QUEENSLAND FLOODS COMMISSION OF INQUIRY
REVIEW OF HYDRAULIC MODELLING
FINAL REPORT

**REVIEW OF HYDRAULIC MODELLING
QUEENSLAND FLOODS COMMISSION OF INQUIRY**

FINAL REPORT

Project Review of Hydraulic Modelling Queensland Floods Commission of Inquiry		Project Number 111024	
Client QLD Flood Commission of Inquiry		Client's Representative Lisa Hendy	
Authors Mark Babister Stephen Gray Rhys Hardwick Jones		Prepared by 	
Date 28 JULY 2011		Verified by 	
Revision	Description	Date	
1	FINAL	JULY 11	
2	FINAL (Revised 28/07/11)	JULY 11

Figure 1: Velocity Time Series (modelled) at Jindalee (SKM Model Version 1)

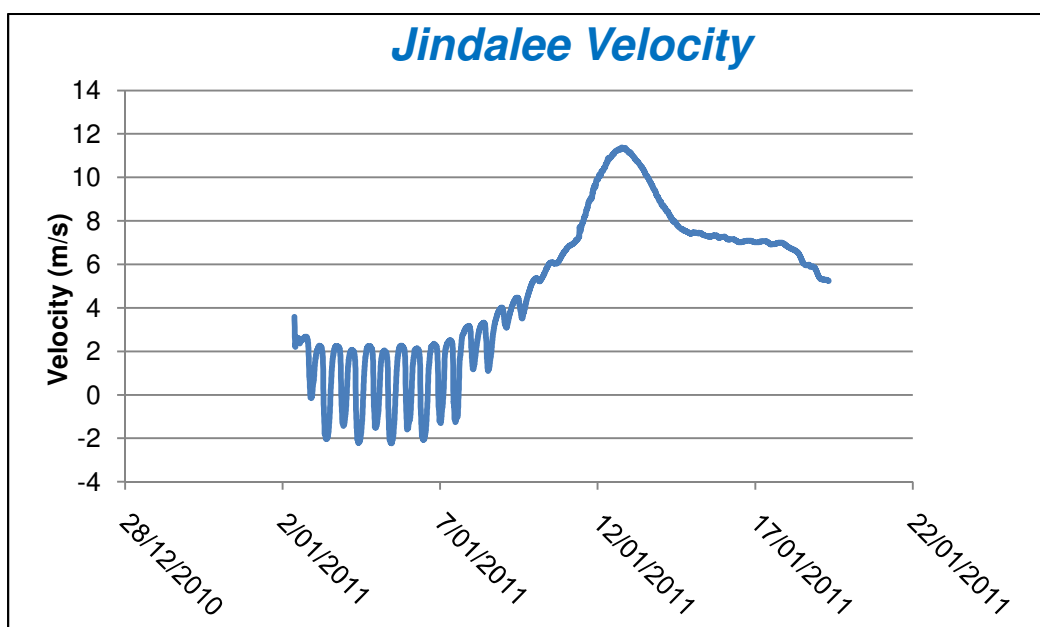
- 28 The WMAwater review of the Version 1 model found some issues with the model build which undermined the legitimacy of calibration and scenario runs as presented in the recent report by SKM and Seqwater (Reference 2). Figure 1 to Figure 4 demonstrate the issues which are summarised below:

- a. Flow velocities modelled were unrealistically high (cross-sectional average velocities greater than 10 m/s);
 - b. Model stability was poor;
 - c. Roughness values were artificially high, presumably to compensate for high flow velocities; and

- d. Run time was excessive.
- 29 Overall the issue which led to most problems in the model was the resistance approach used. In summary, there are two possible issues with the use of the “Resistance Radius” approach (as adopted in the Version 1 SKM model). First, when used in conjunction with relatively high flow zone multiplier values it leads to artificially constrained cross-sectional area within the processed value table of the cross-section (*.xns11) files used in Mike11. Second, the “Resistance Radius” approach is less suited to deep cross-sections with steep side slopes as are found in many locations on the Brisbane River. Through some combination of these two mechanisms very high mean velocities were modelled (see Figure 1). The high modelled velocities were approximately 4-5 times what was achieved using an alternative resistance formulation and compared to gauged velocities at Jindalee were demonstrably false. The high modelled velocities in turn seemed to exacerbate stability issues and require the higher roughness values observed in the model. Please note that velocities presented are average velocity over the entire modelled cross-section, not peak in-bank velocity.

Figure 2: Discharge Time Series (modelled) at Mt Crosby Bridge (Version 1)

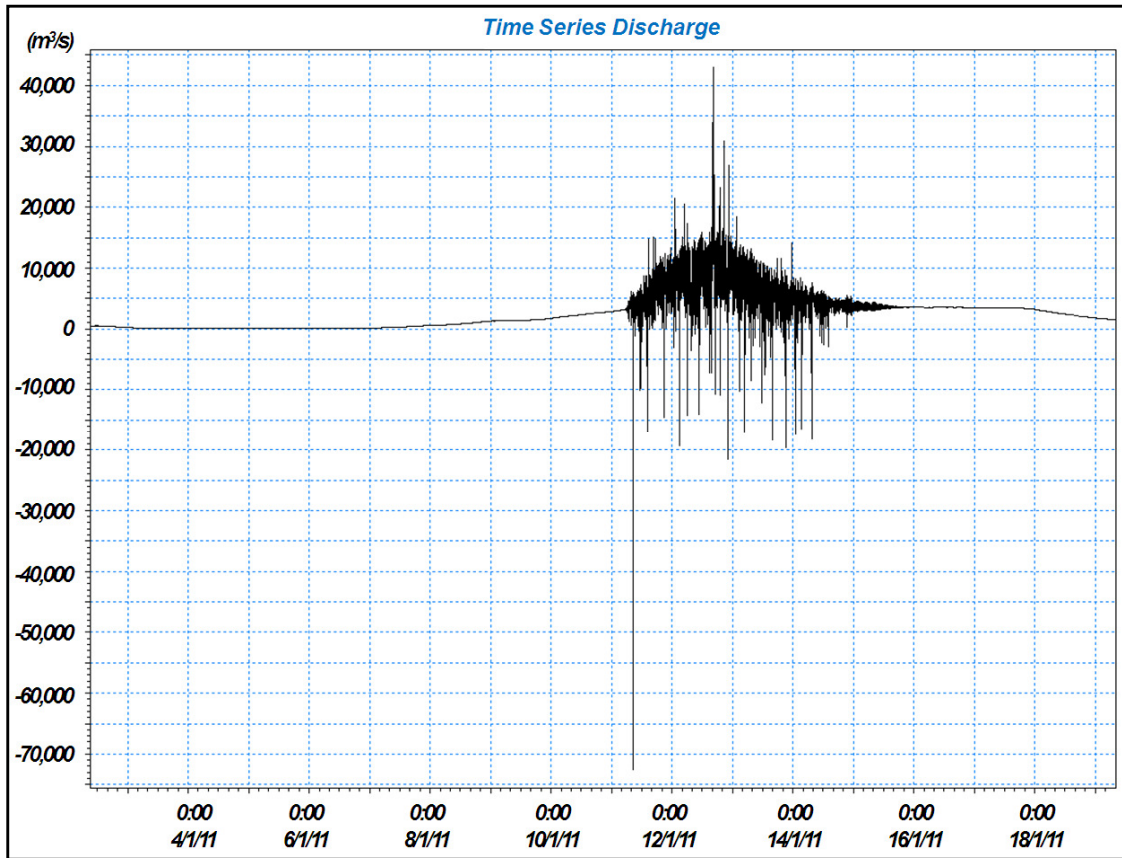
- 30 Figure 2 and Figure 3 indicate the Version 1 model's lack of stability with discharge fluctuating between 40,000 m³/s and negative 70,000 m³/s in Figure 2 (actual discharge peaks at approximately 9,000 m³/s) and the water level fluctuating between approximately 21 mAHD and 28 mAHD in Figure 3 (actual peak water level is approximately 26 mAHD). Note both results are at Mt Crosby Bridge and both results are indicative of the worst of the stability issues in the model.

Figure 4: Model Results (Version 1) at Port Office versus “Fixed” model results

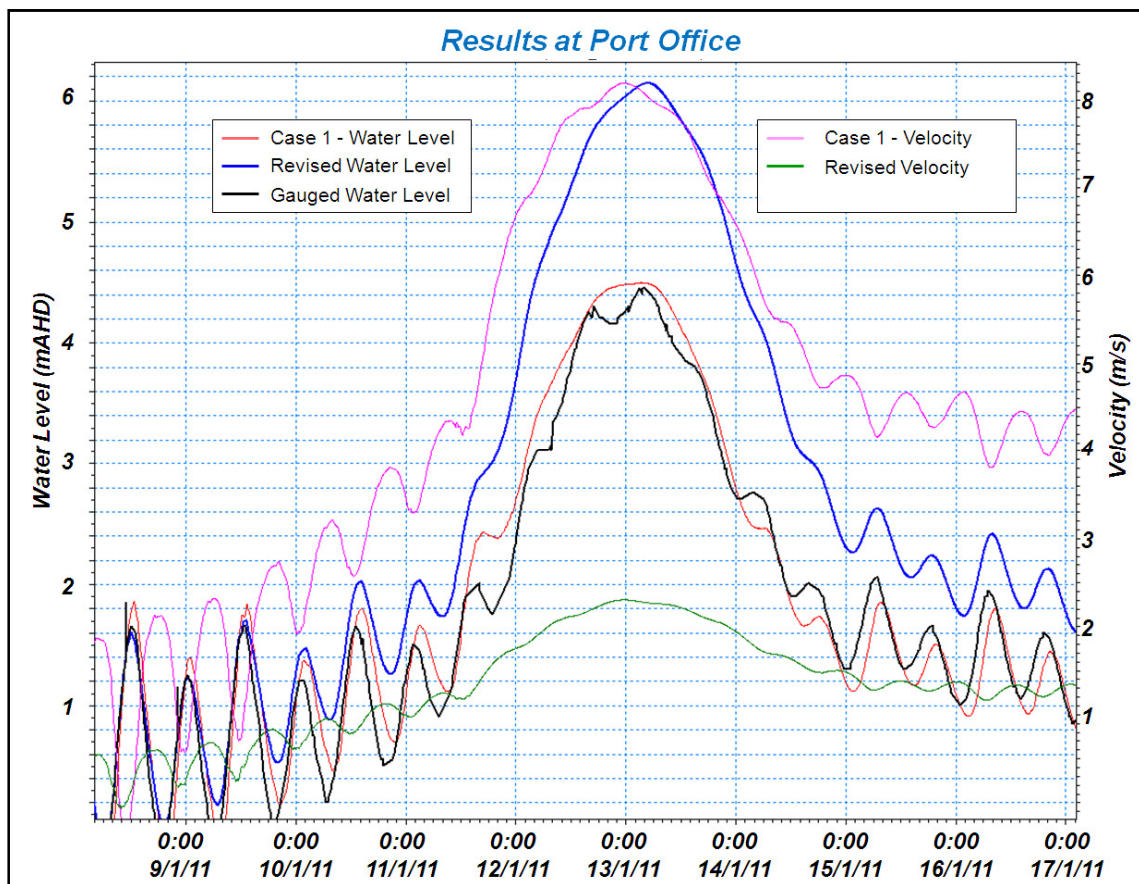
- 31 As part of the review process the Version 1 model was altered to a different resistance method and this reduced maximum cross-sectional average velocities in the Brisbane River from 10 m/s to approximately 2.5 m/s. The impact this change had on model results in the Version 1 model is shown in Figure 4. Note that whereas previously, with the unreasonably high velocities, the modelled water level was a good match for the gauged water level at Port Office, when the velocities are a more reasonable value (see “Revised Velocity” versus “Case 1 Velocity” in Figure 4), the modelled peak water level increases from 4.5 mAHD to approximately 6.2 mAHD. This demonstrates that the parameters used in the Version 1 model did not produce a reasonable match for both water level and velocity at the Port Office gauge. When there was a good match for water levels, velocities were too high, and when velocities were at a reasonable magnitude, water levels were too high.

Figure 5: Mike11 Cross-Section with insufficient floodplain detail

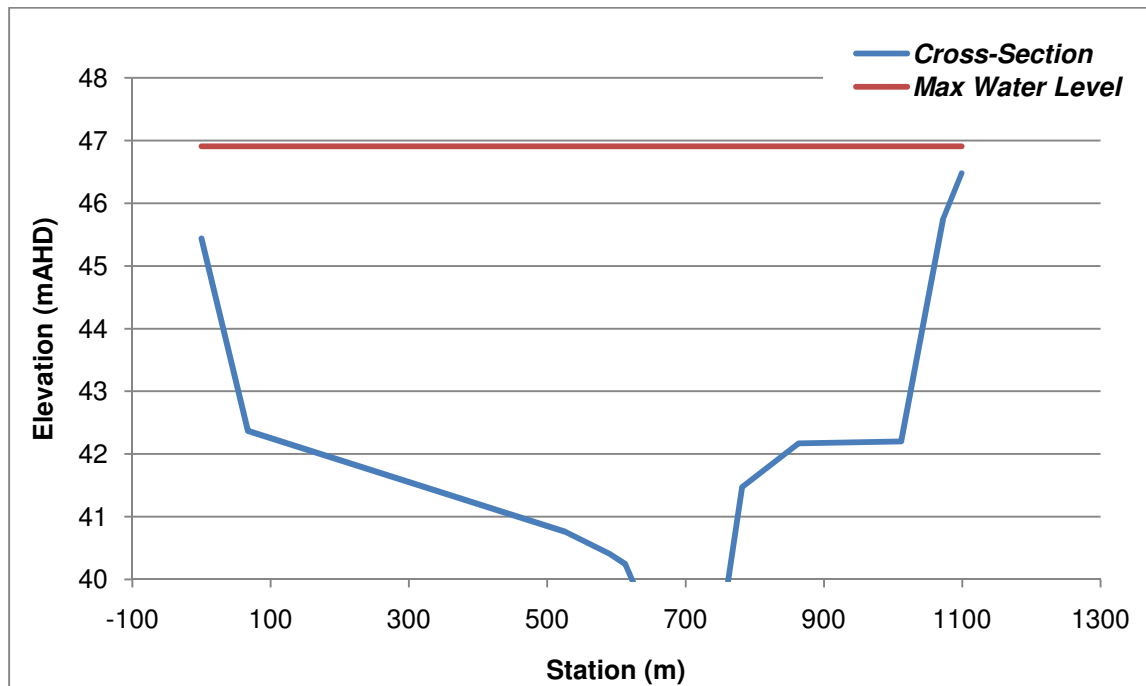
- 43 An issue noted with regard to the model cross-sections is that in some cases the cross-sections contain an inadequate amount of the floodplain and as such are subject to extrapolation error. This situation will typically overestimate peak flood level and lead to underestimation of system attenuation. An example is shown in Figure 5 for a cross-section at chainage 934,270 m on the Brisbane River, approximately four kilometres downstream of the Wivenhoe Dam outlet. Note that peak water level exceeds the defined topography. In such a situation Mike11 extrapolates vertically from the defined top left bank and top right bank. This issue was only observed in a small minority of model cross-sections and is unlikely to affect the model results significantly.

Figure 6: Comparison of gauged and modelled water level – Mt Crosby

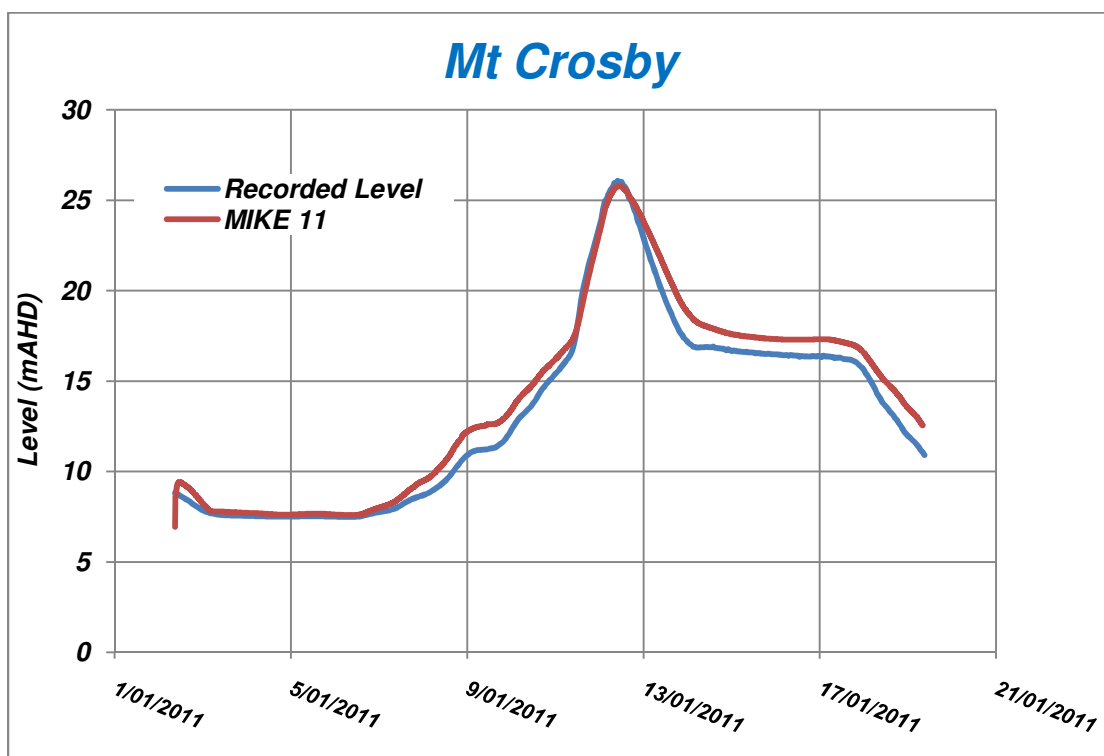
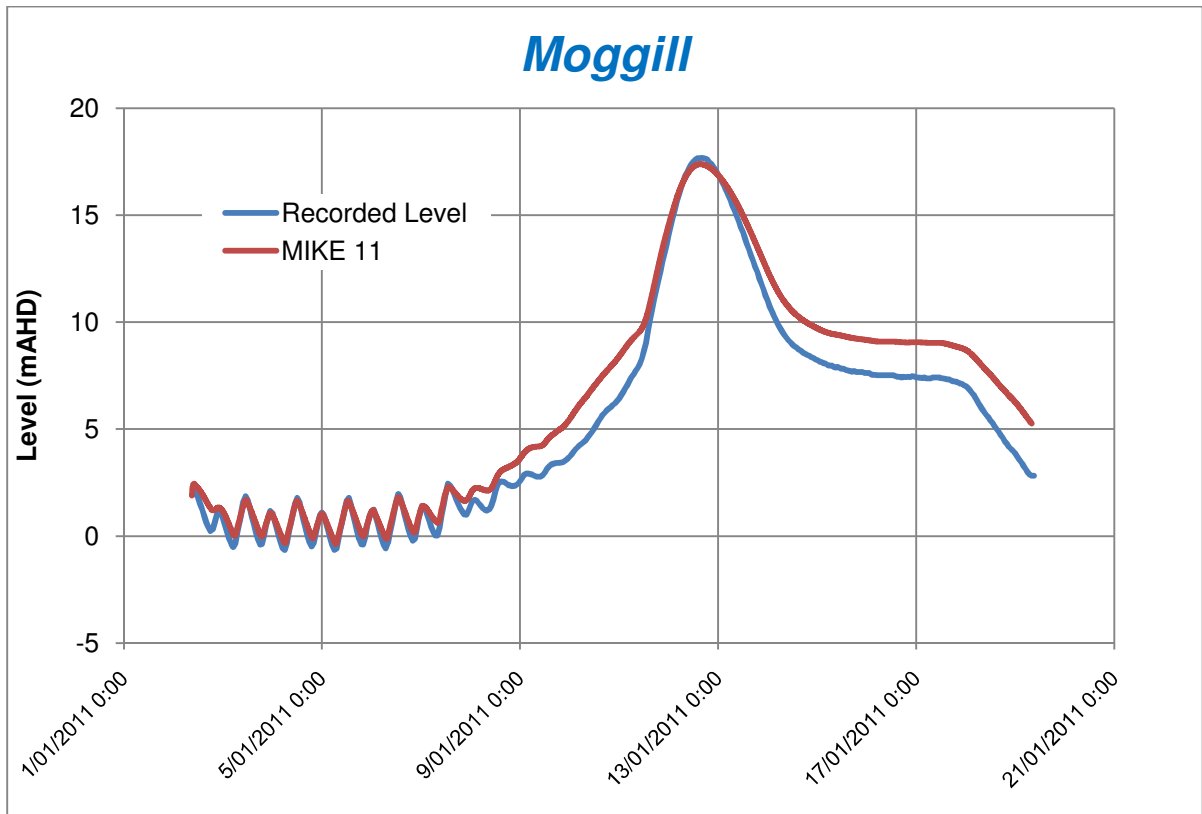
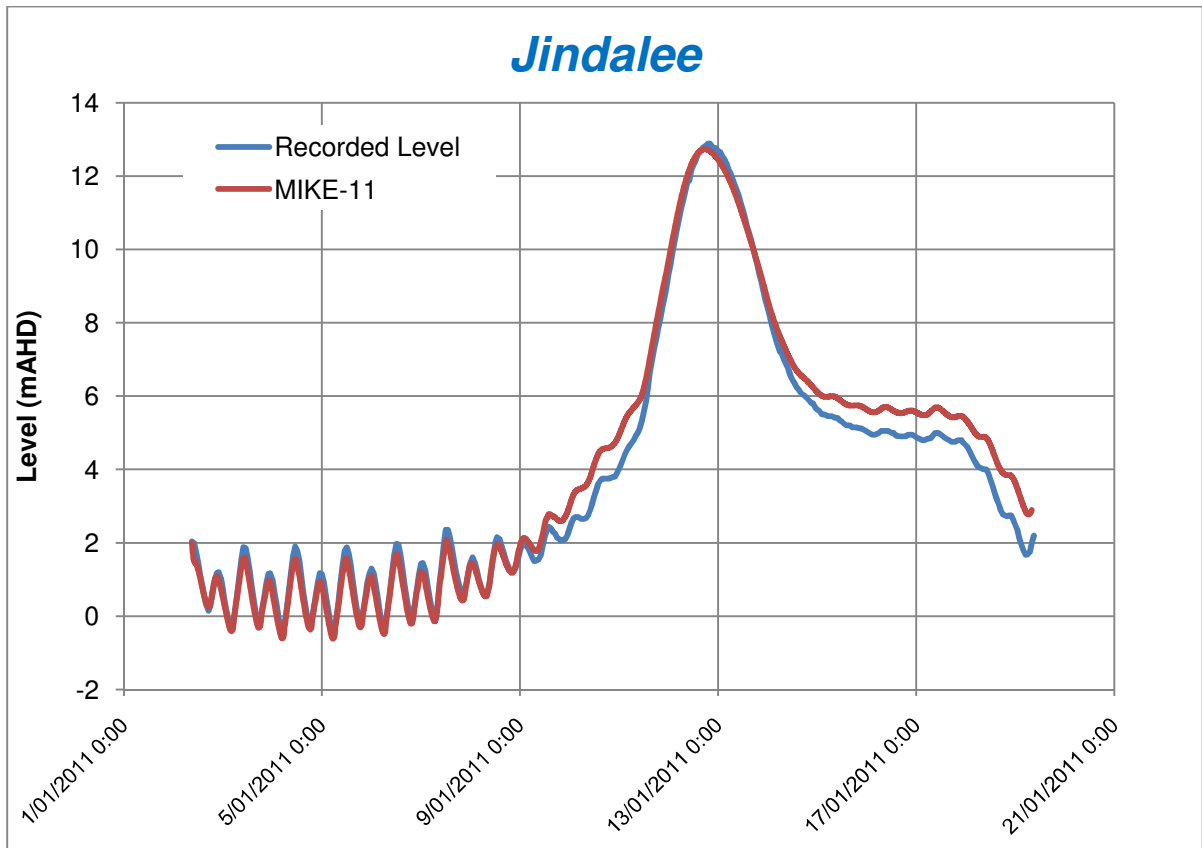
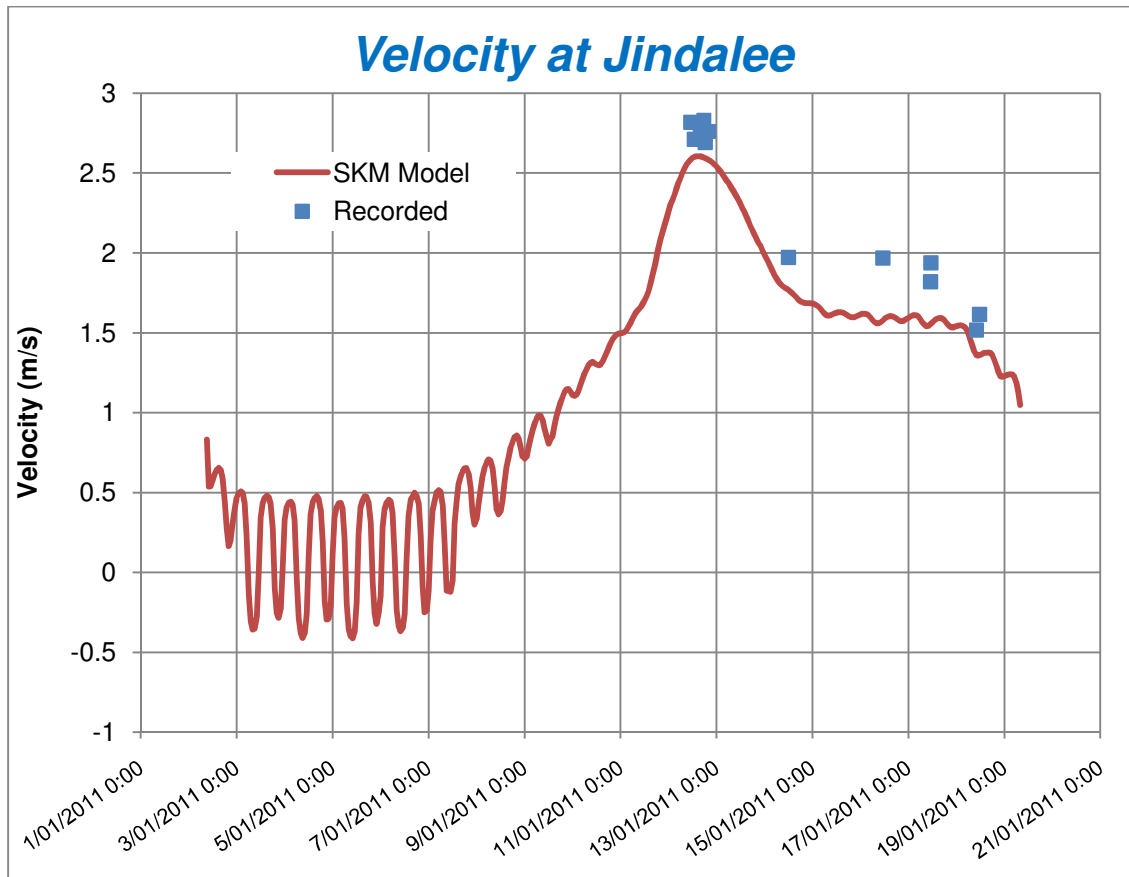
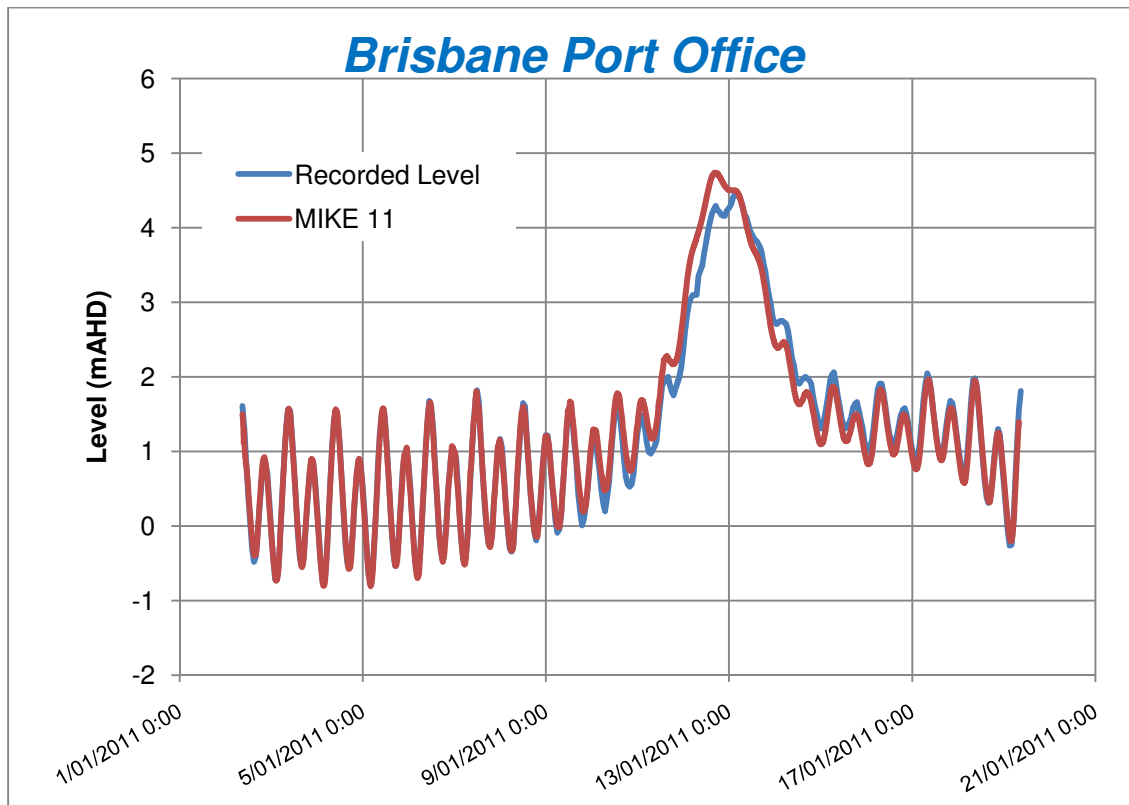
- gauged discharge at Jindalee during event; and
 - recorded water level at Moggil, Jindalee, Oxley and Port Office.
- 49 Figure 6 to Figure 10 describe the calibration result. Overall the match between gauged and modelled water level is excellent at Moggil and Jindalee, particularly in regard to peak behaviour. The match is very good at the Port Office although the modelled peak does occur too early at this location. The match to mean velocity between modelled and observed data is excellent. Modelled discharge at Jindalee is also well matched with the model estimating discharge at close to 10,000 m³/s, as per the gauging. The match to Mt Crosby is excellent but less relevant since this point was used to derive the input flow and also because it is located directly next to a major model boundary.

- 50 The model has a tendency to underestimate observed routing time, with the effect most evident at Port Office, the furthest distance (67 kilometres) downstream of Mt Crosby. The tendency of the model to have the flow arriving early relates to the likelihood that the model does not currently represent the storage of the system and resulting attenuation of flood flows, particularly between Jindalee and Port Office. The effect is slight however and likely exacerbated by the timing relative to the tide.

Figure 11: Flow chart describing the derivation of All upstream Mt Crosby Input Hydrograph

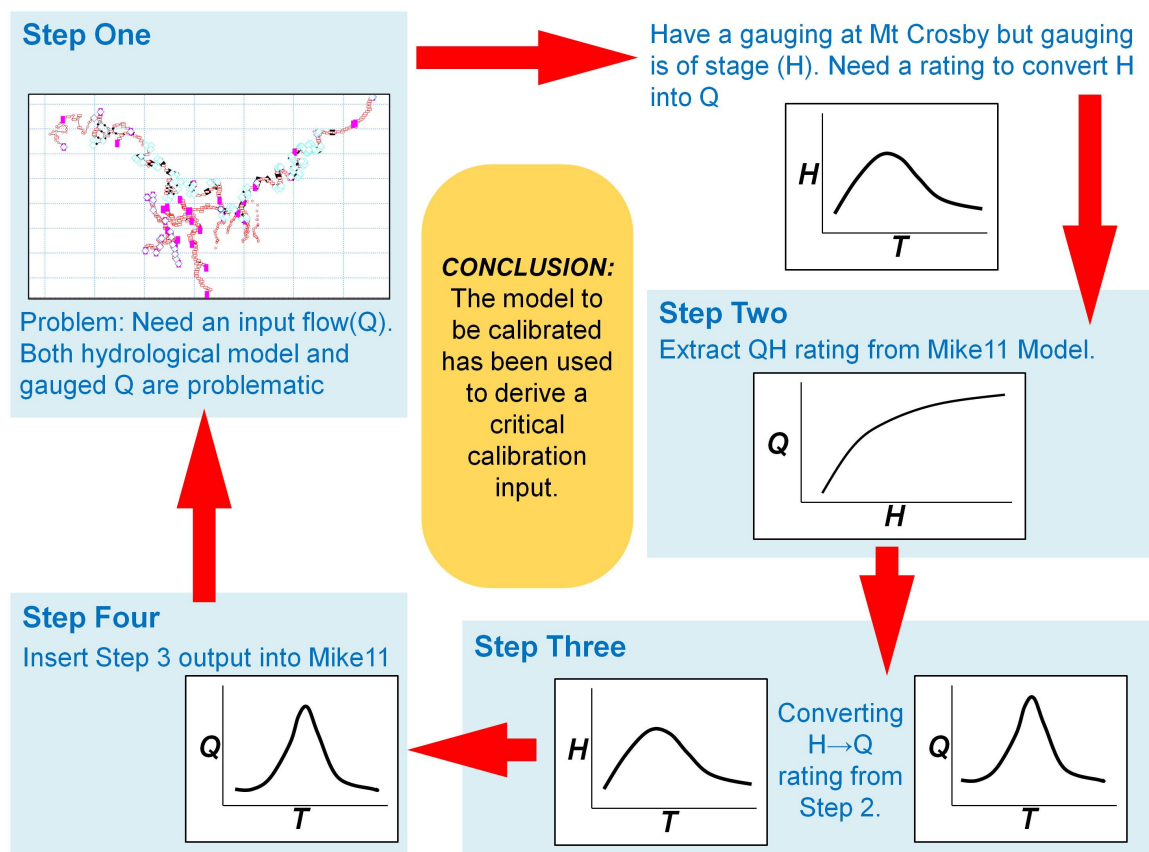
- 52 Boundaries – Whilst the model domain includes the Brisbane River up to the outlet of Wivenhoe Dam the January 2011 event does not include tributary inputs such as Lockyer Creek inflows and other local inputs. Instead a lumped accumulation of inputs upstream of Mt Crosby Bridge (minus Wivenhoe flow), has been back calculated based on a Mike11 derived rating for the Mt Crosby stream gauge. Figure 11 describes the process and its inherent circularity i.e. the model to be calibrated is used to derive a key calibration input. Also the use of Mt Crosby as a major boundary is non-ideal because it doesn't allow for the adequacy of the model upstream of Mt Crosby to be assessed during the calibration. The same approach could presumably have been carried out at Lowood, approximately 50 kilometres up river, extending the overall portion of the model useful for analysis and interpretation.
